# 3010 APARTMENTS

3010 & 3014 SW AVALON WAY, SEATTLE, WA

SDCI Project #3035979-LU  
Recommendation Meeting  
Southwest Design Review Board

NORTH PROJECTION

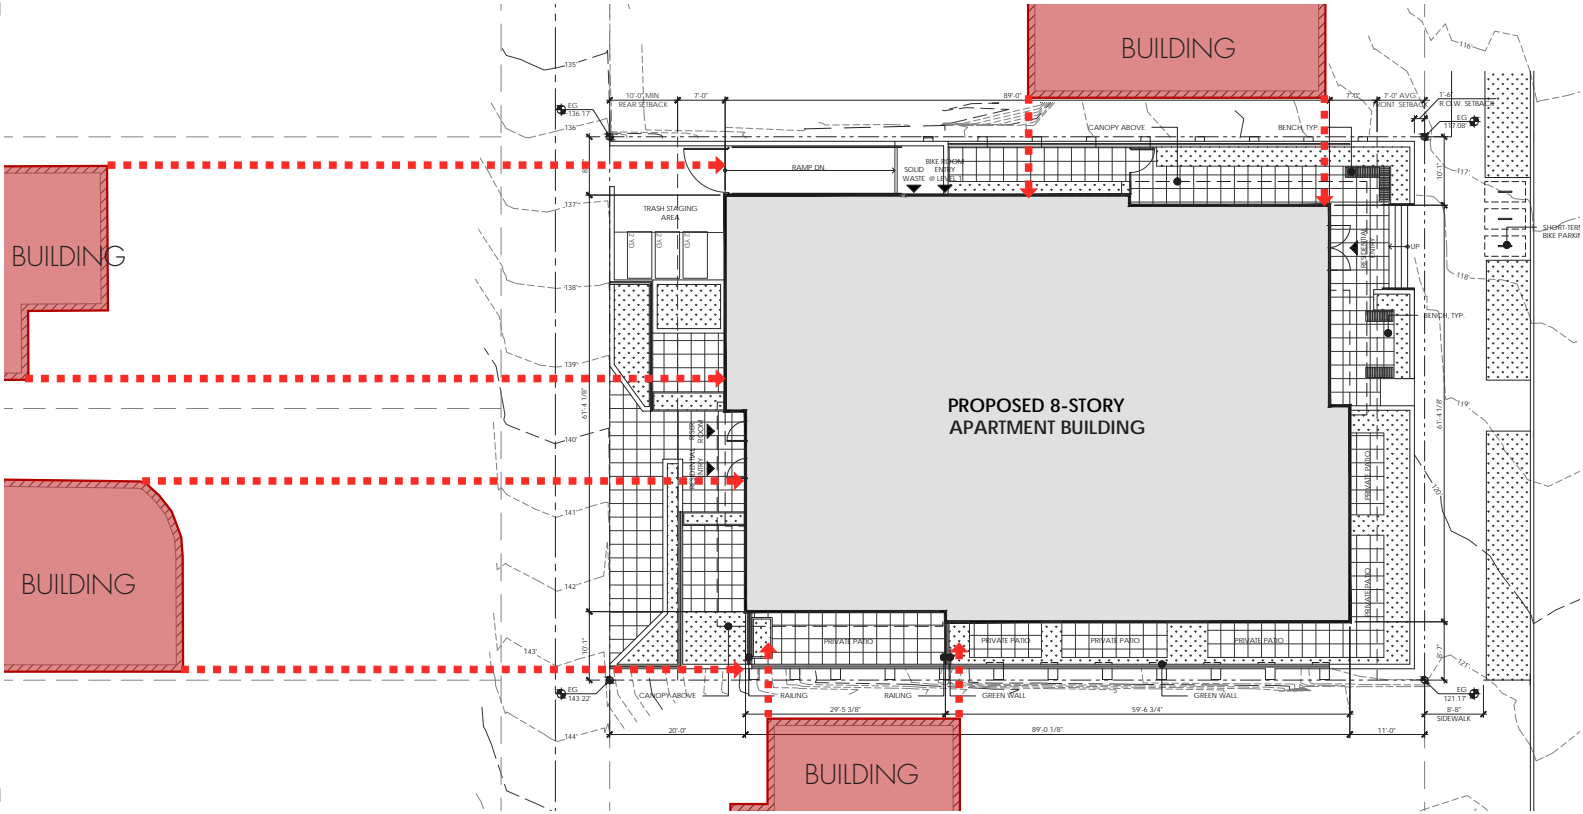
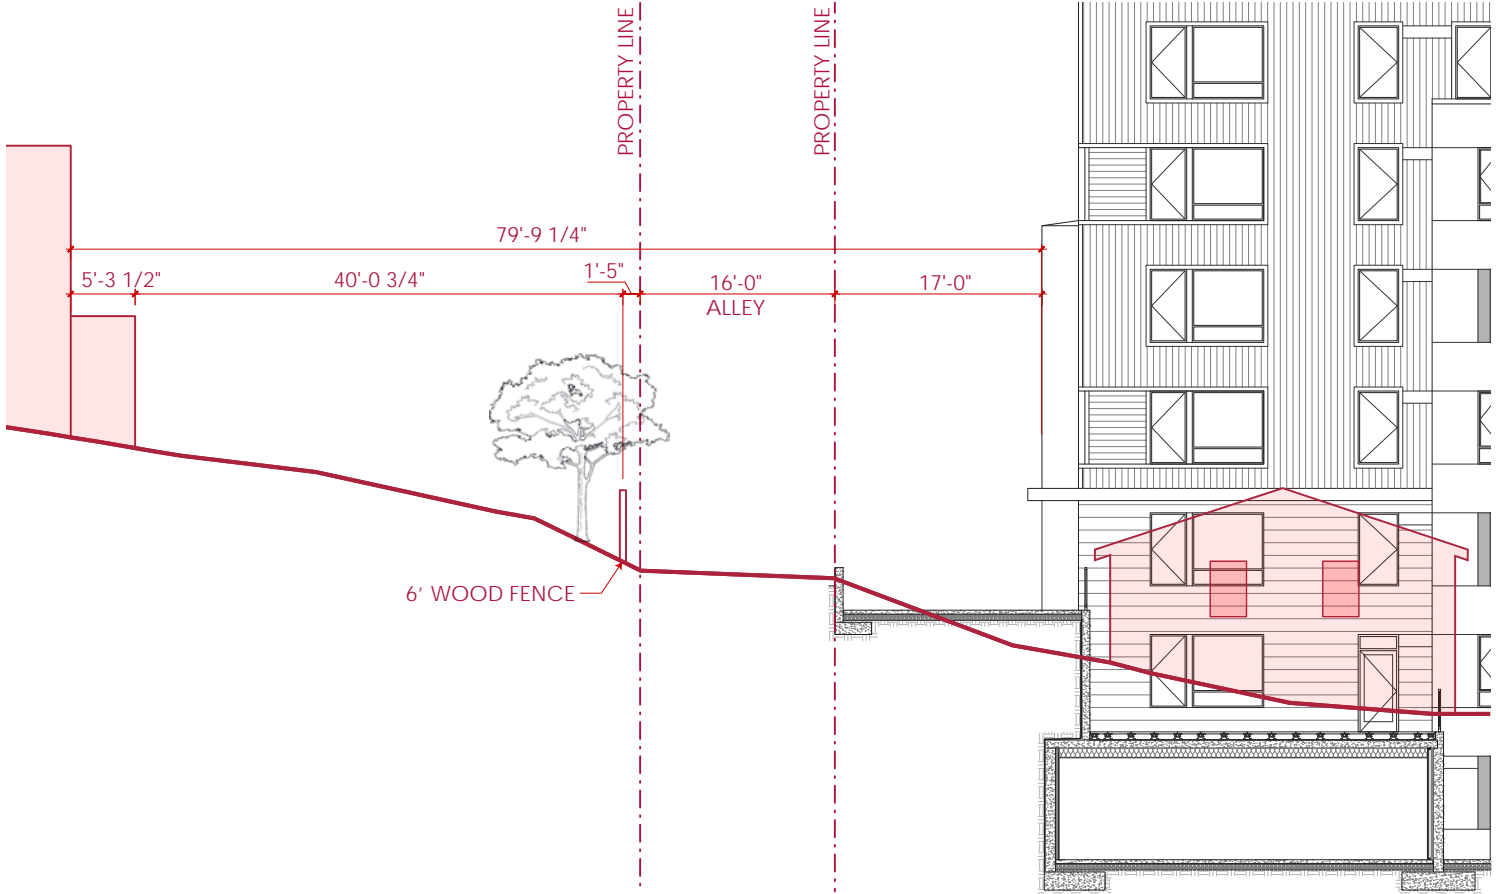
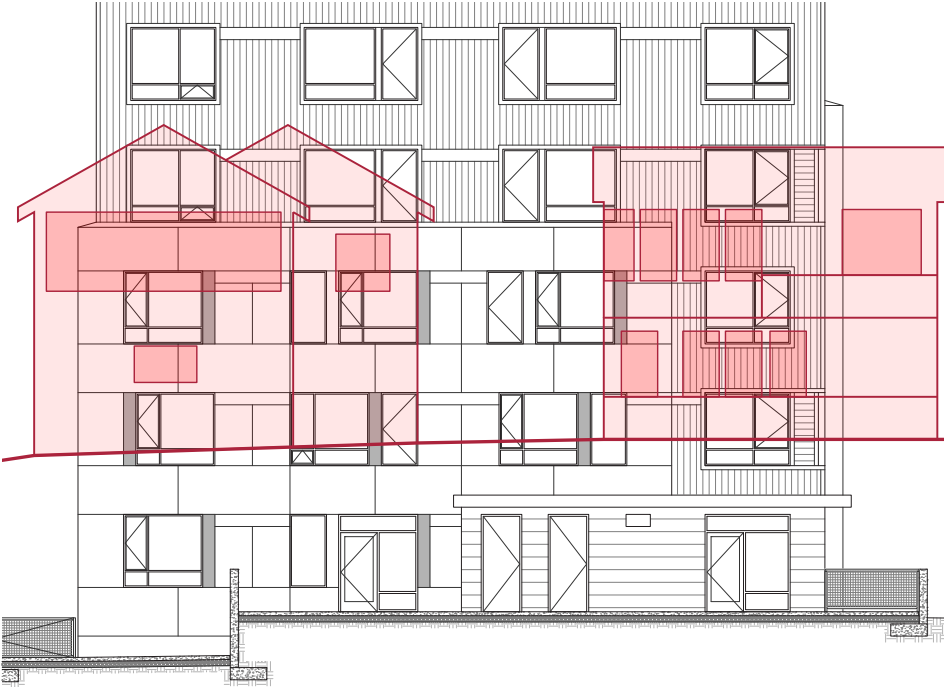
e. Although fenestration patterns were not explicitly shown on the massing options in the EDG package, the Board noted that privacy between the new and existing residential uses is a concern. They requested a privacy study in the Recommendation package, showing sight lines between the proposed units and the building to the north, as well as to the single family structures to the west. (PL3-B)

A study has been included showing the sight lines for the adjacent buildings to the north and west. As seen in the studies there are no direct sight line conflicts between the window locations for each building.

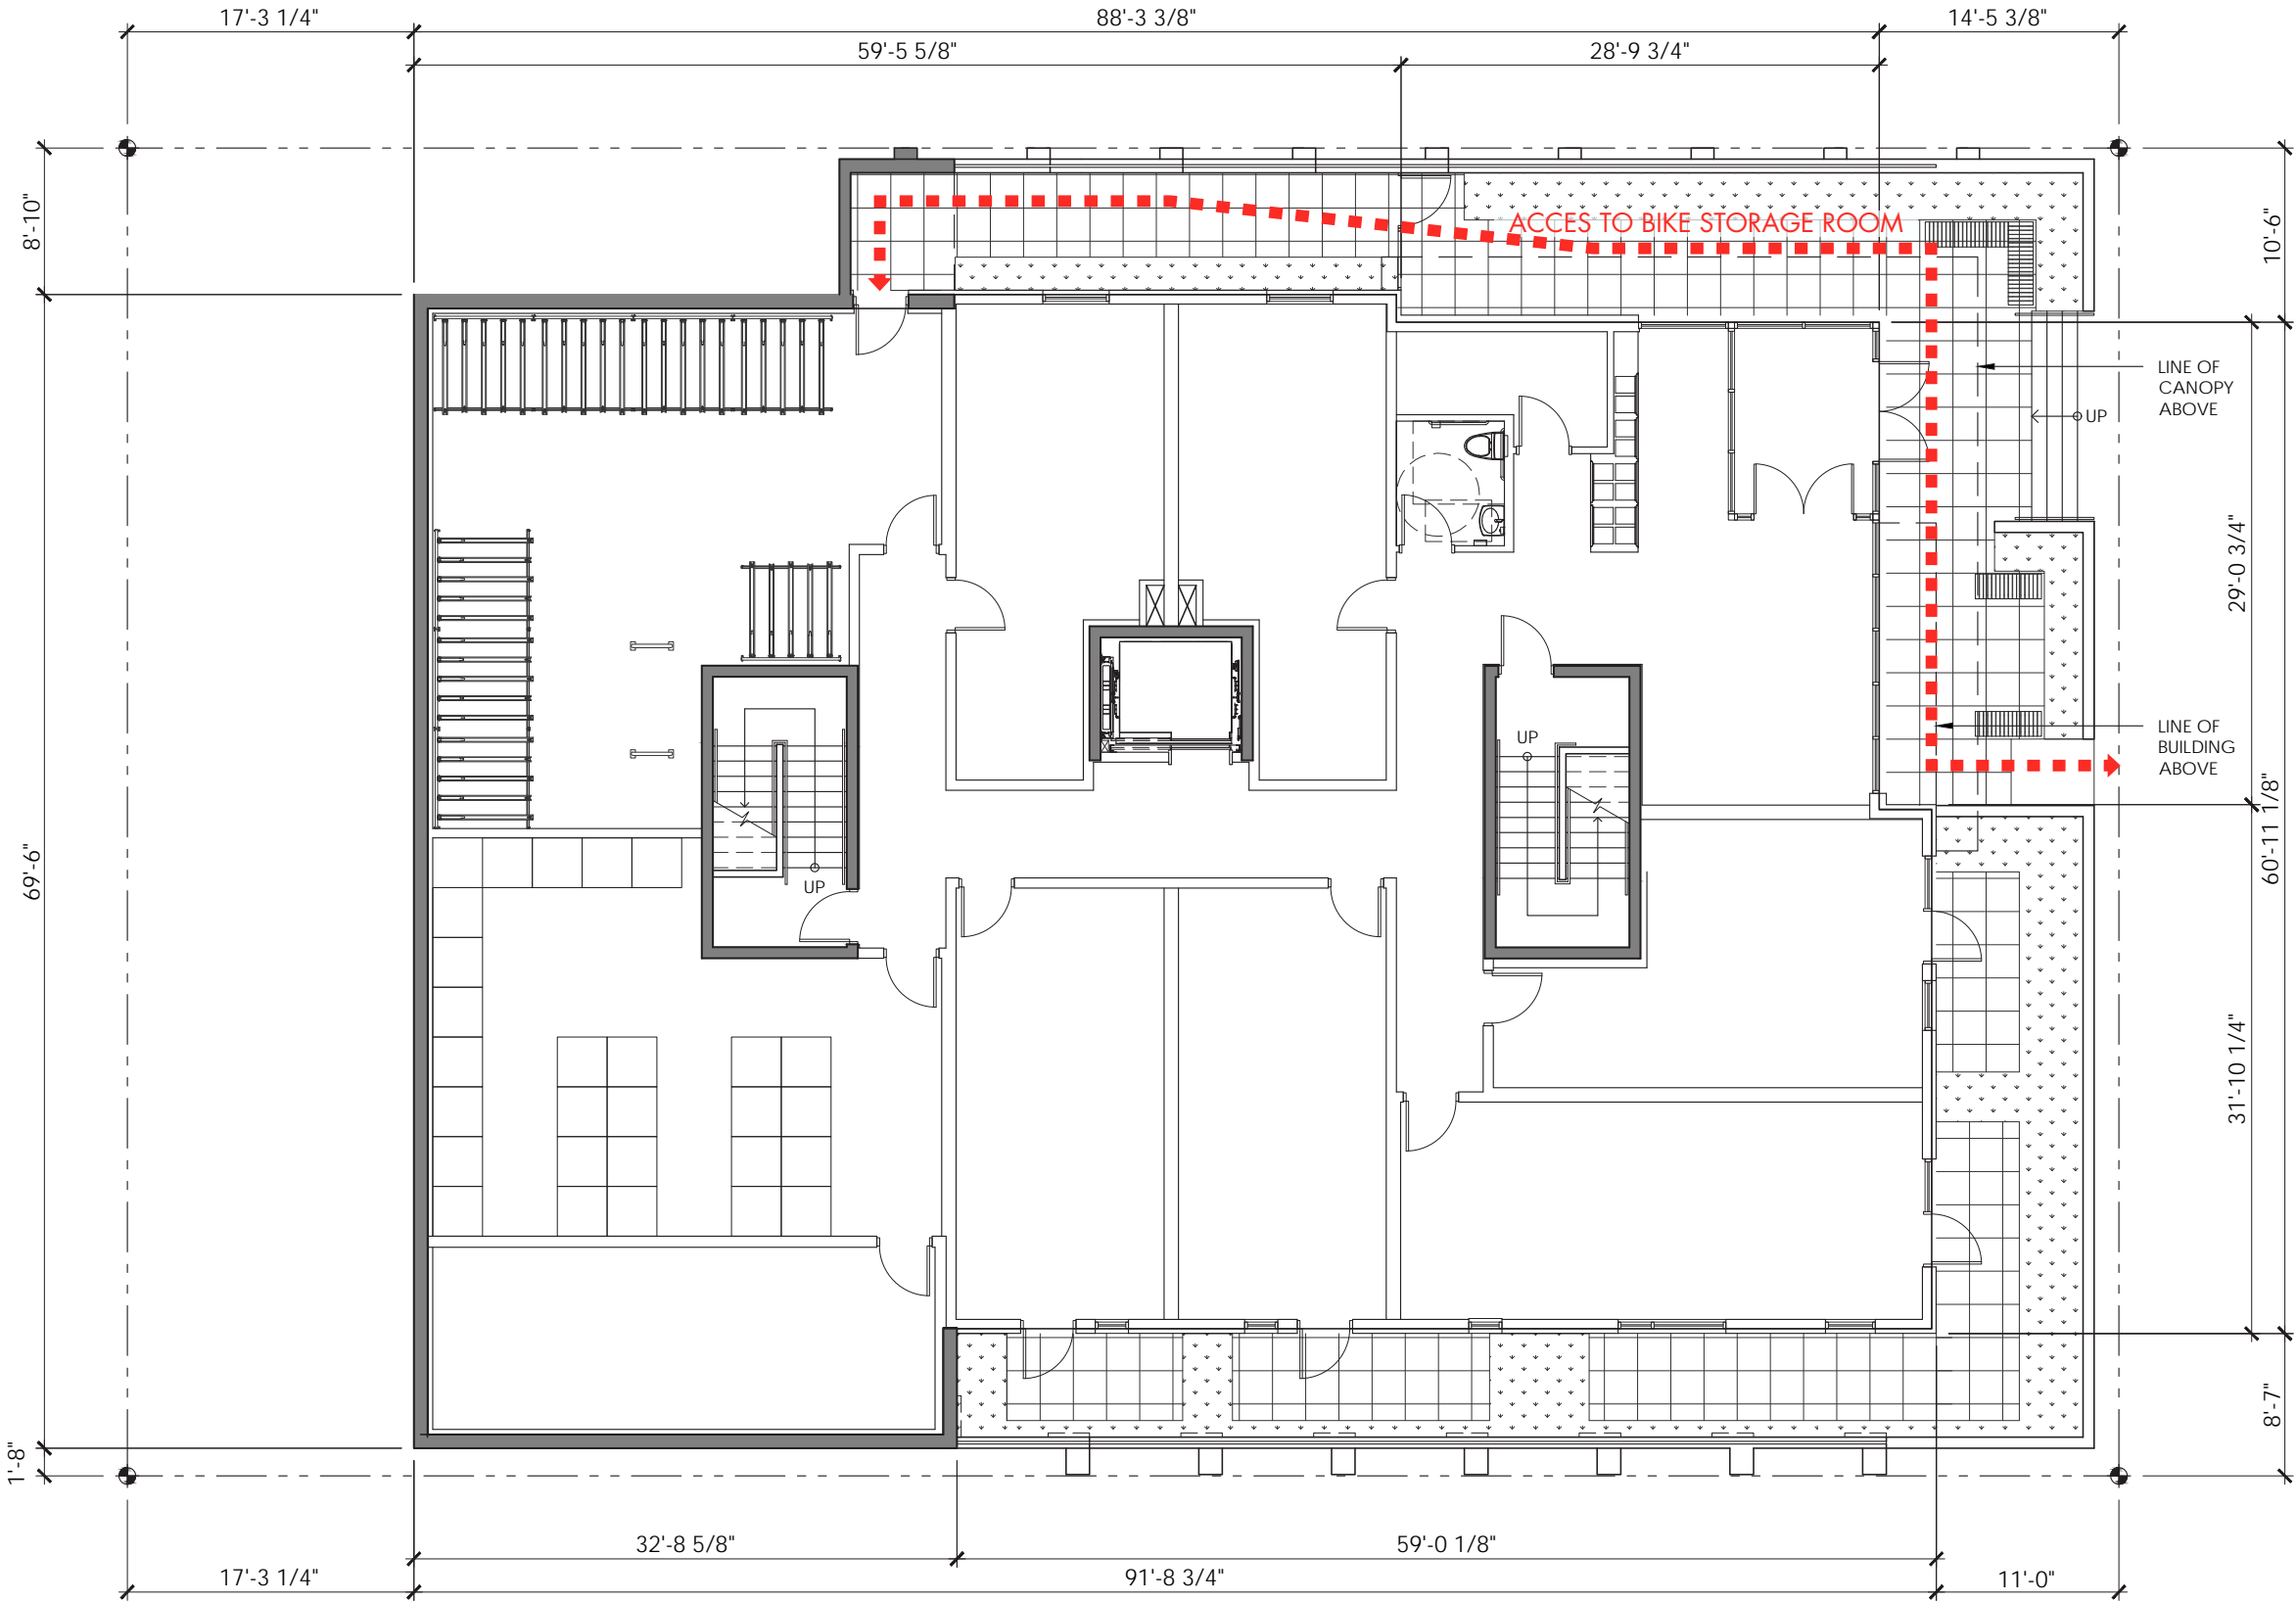
f. The Board noted that direct access through the lobby to the bike storage room, as shown in Massing Concept 2, was acceptable. They noted that although an exterior access to the bike parking is typically desired (as shown in Massing Concept 1), the clear access from the bike lane on Avalon Way through the front door and lobby to the interior bike storage room was an acceptable trade-off for providing exterior patio space to the ground floor units. (PL4-B, and PL4-A)

With the revised design we were able to make the bike parking room accessible from the north property line and easily accessible from the street as well.

CROSS-SECTIONAL STUDIES

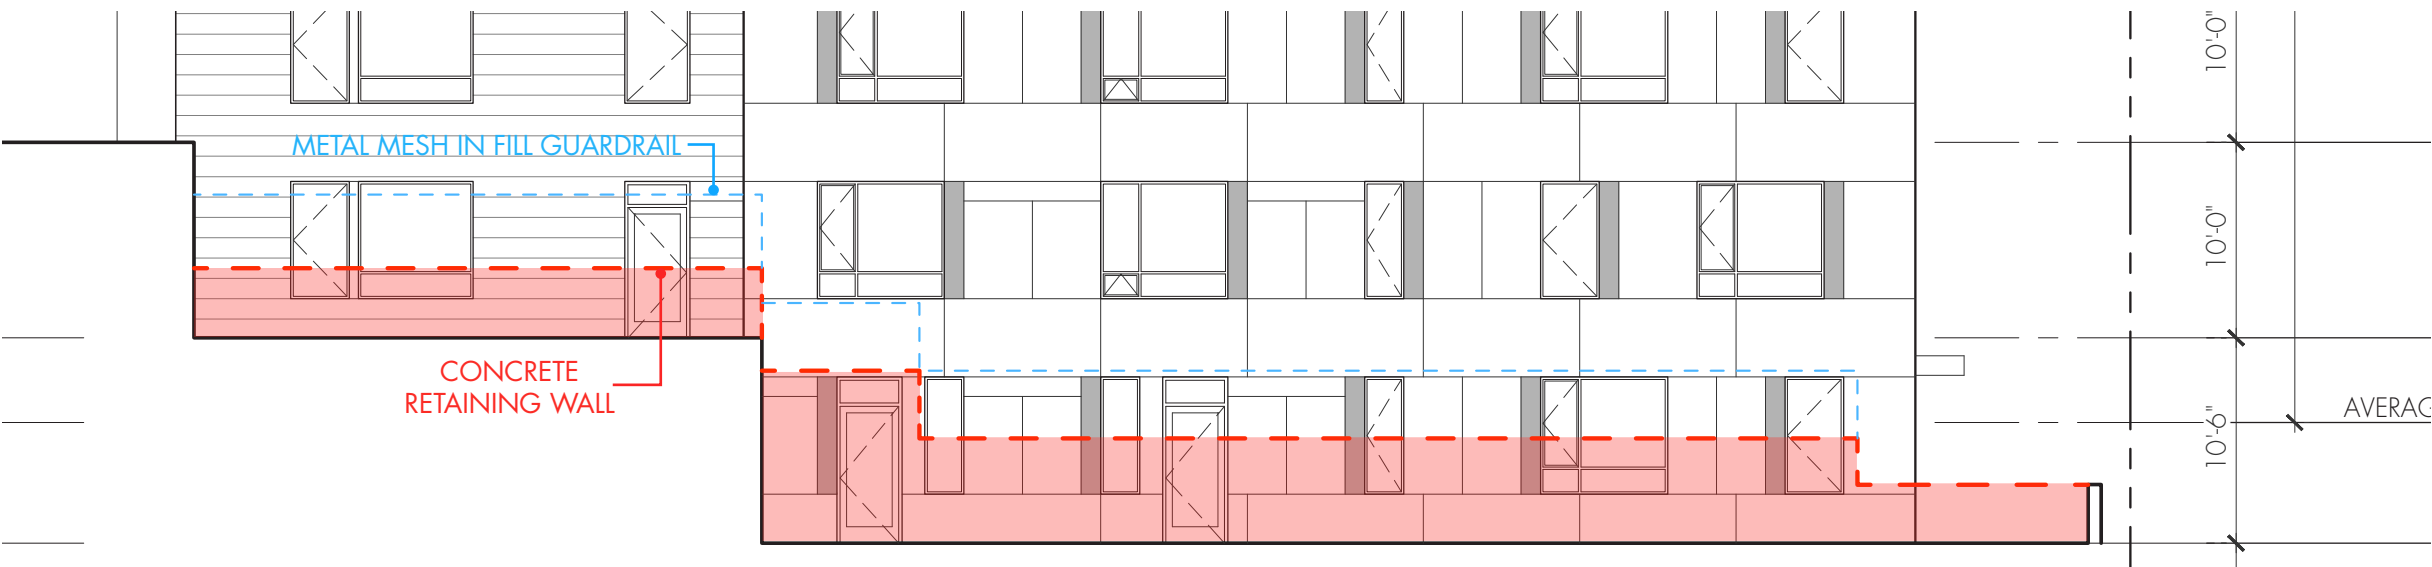
g. The Board was, however, concerned about the viability of the patio spaces of the ground floor units' access to light, since they are adjacent to the tall retaining walls shown in the EDG packet. The Board requested cross-sectional studies to clarify conditions at the below-ground level units and demonstrate how the outdoor space provides benefit to the units. (CS1-B)

Studies have been provided for review. The design keeps the solid concrete retaining wall following the existing neighboring grade as close as possible to ensure as much light can get into the patio spaces as possible and an open fence has been designed on top of the wall to allow light to pass through as well. As seen, there is ample light that comes into these spaces. A green wall is also designed on the face of the concrete wall to provide greenery and warmth to the area. Planting areas are also provided at the base of the wall and between units for privacy.

SEMI-PUBLIC  
AMENITY  
SPACE

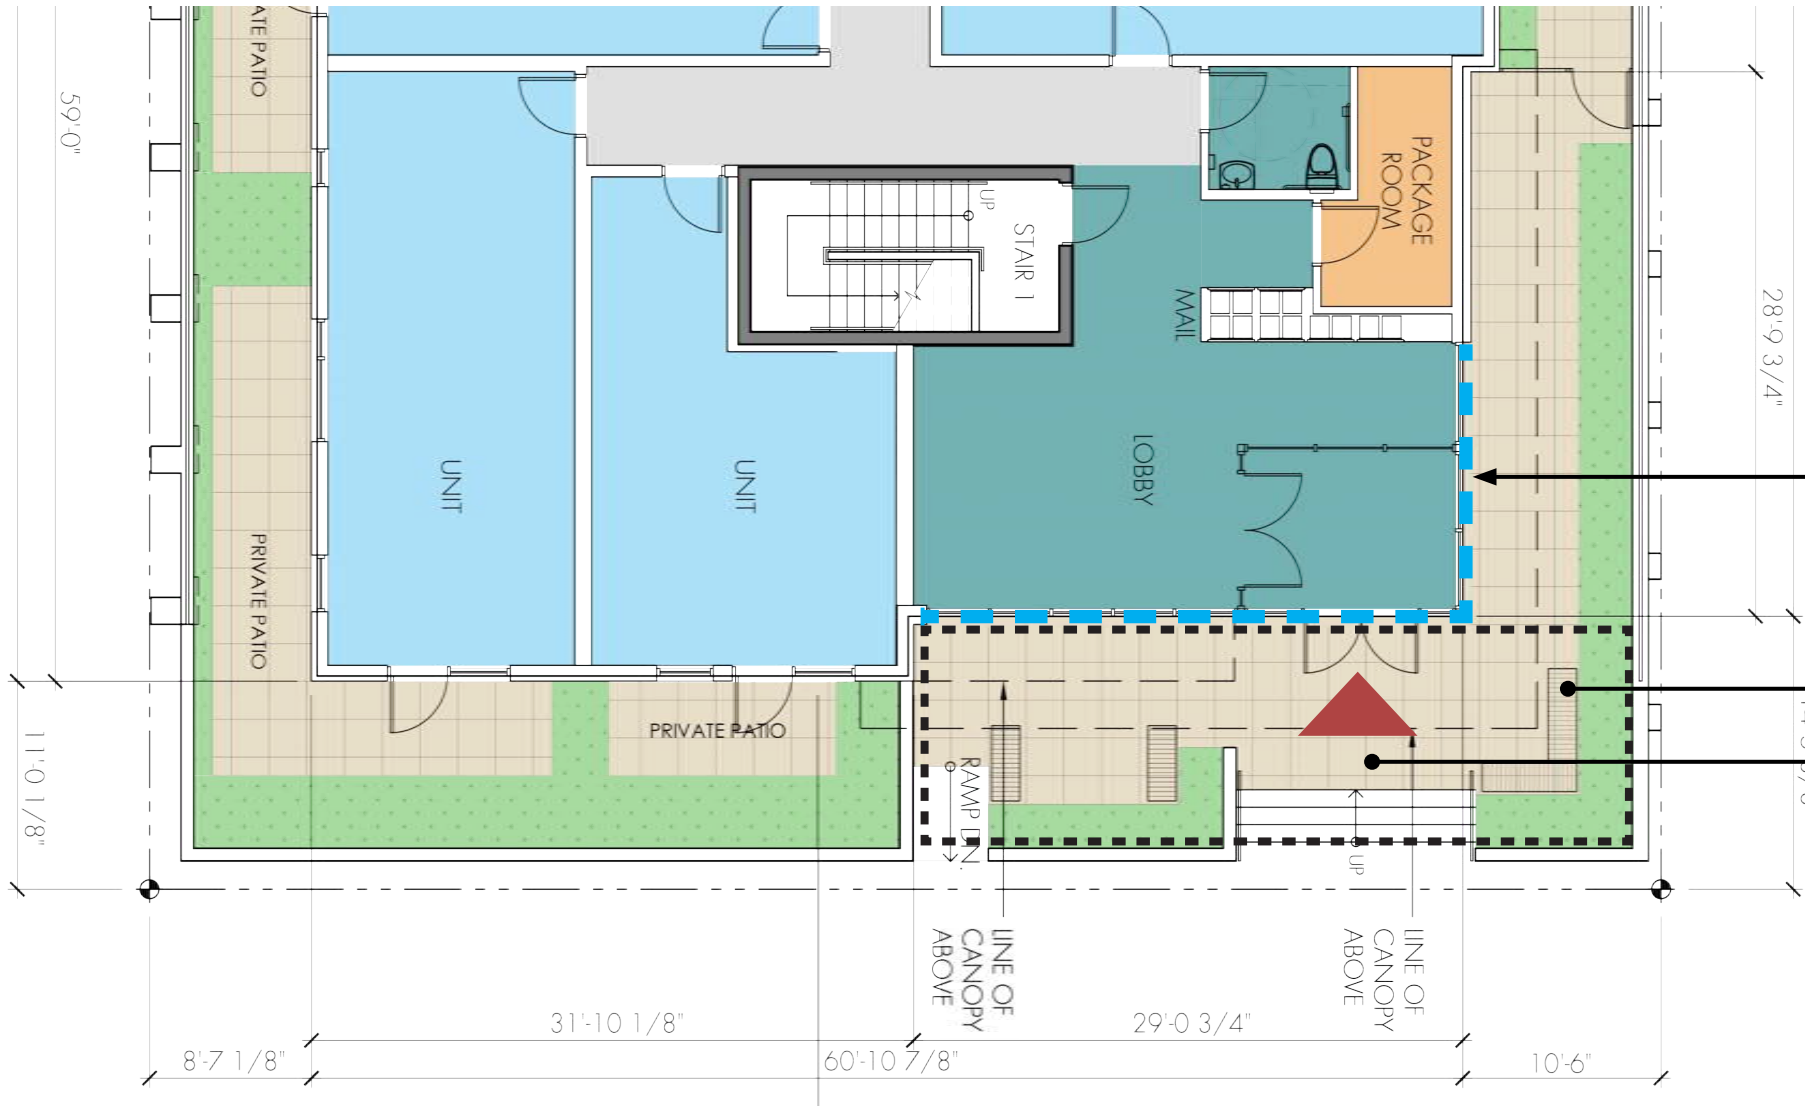
a. As previously described, the Board supported the entry sequence shown on Massing Concept 3, with an on grade access to the main entrance from the Avalon Way frontage. The Board noted that the location of the associated patio near the entrance will help to activate the street frontage in a neighborhood where many buildings are grade-separated from the sidewalk due to steep grades. (PL3-A, PL3-B-4, and DC2-II-i)

Per the Board's recommendation the entry has been moved to the northeast corner of the site and the residential entrance and plaza have been raised up a few steps from the sidewalk in order to make the plaza semi-public and also activate the street front. Seating, landscaping and a covered area at the building façade have been designed into the space.
